Reference: Traffic Study Peer Review **MEMO #4**
Chapter 40B, 1299 Beacon Street
Zoning District G-1.75, Precinct 10

At the request of my clients, Roberta Sydney and Kyle Spellman, on behalf of KS Company Trust at 1309-1319 Beacon Street, I have reviewed revised architectural plans dated June 25, 2019 as prepared by CBT.

PARKING LEVEL 2
 1299 Beacon Street 1299 Beacon Street Brookline, MA
 DATE: 06/25/19

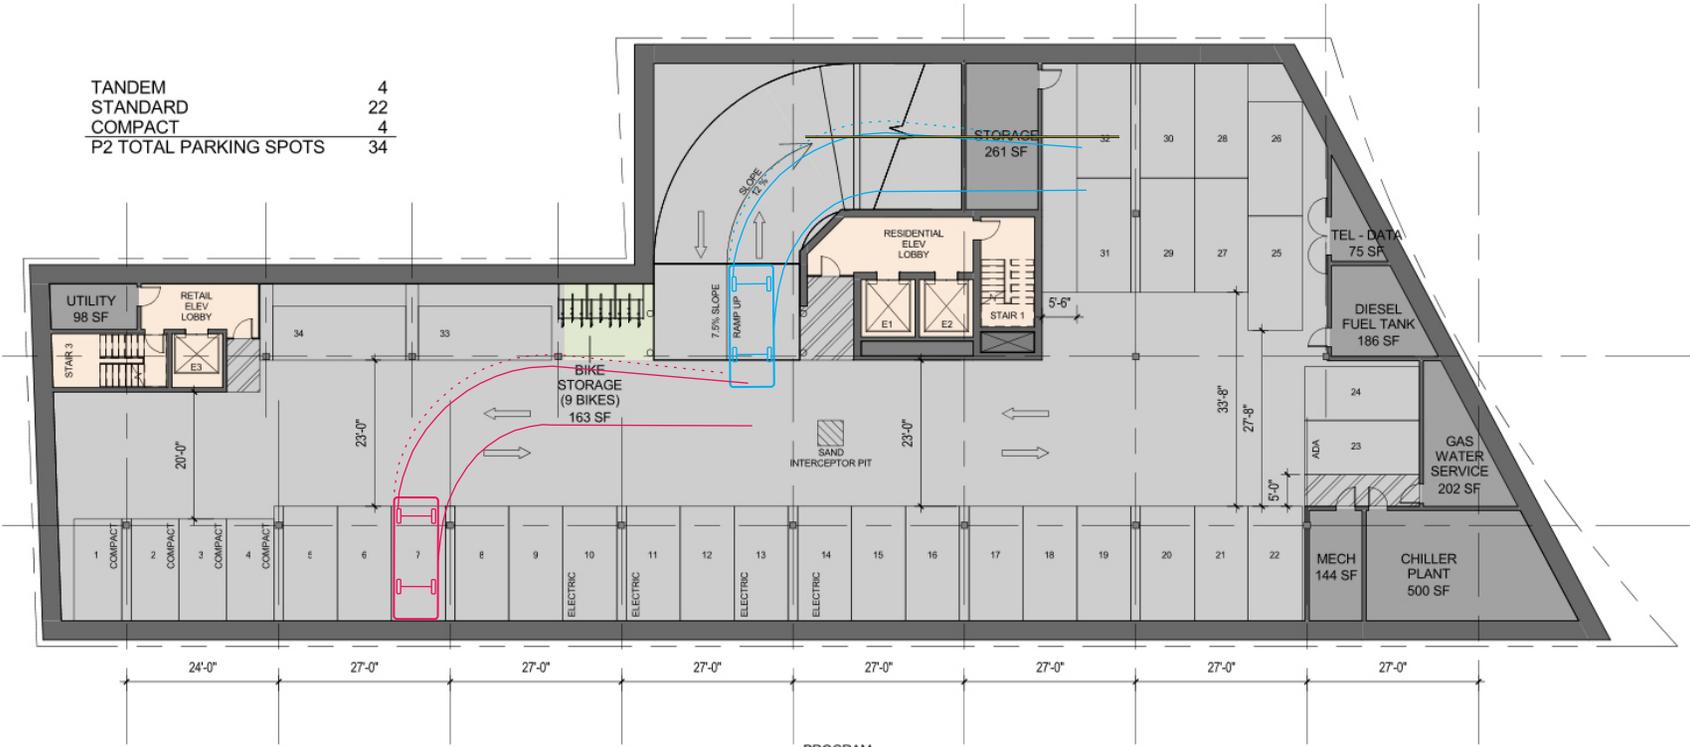
In reviewing “Parking Plan – Level P2”, it appears the standard parking spaces are 8 ½’ wide as well as the compact spaces. While this may be acceptable for some residential projects, it should not be allowed on commercial or even mixed-use developments. The 27’ on-center dimension for three parking stalls is deceiving since the support columns probably have about a 16” diameter. In any event, the spaces scale 8 ½ feet wide.

The graphic sheet attached hereto shows the substandard aisle width of 23 feet will be a problem for vehicles leaving a space where the dotted red overhang line shows a vehicle hitting another vehicle then a supporting building column.

The dotted blue turn line on the ramp shows exiting vehicles maneuvering over the down aisle double yellow center line where sight distance is already an issue. The ramp center line radii appears to be about 20 ½ feet as compared to the AASHTO design vehicle having an outside overhang radii of about 25.4 feet for vehicles leaving level P2 up the ramp to street level.
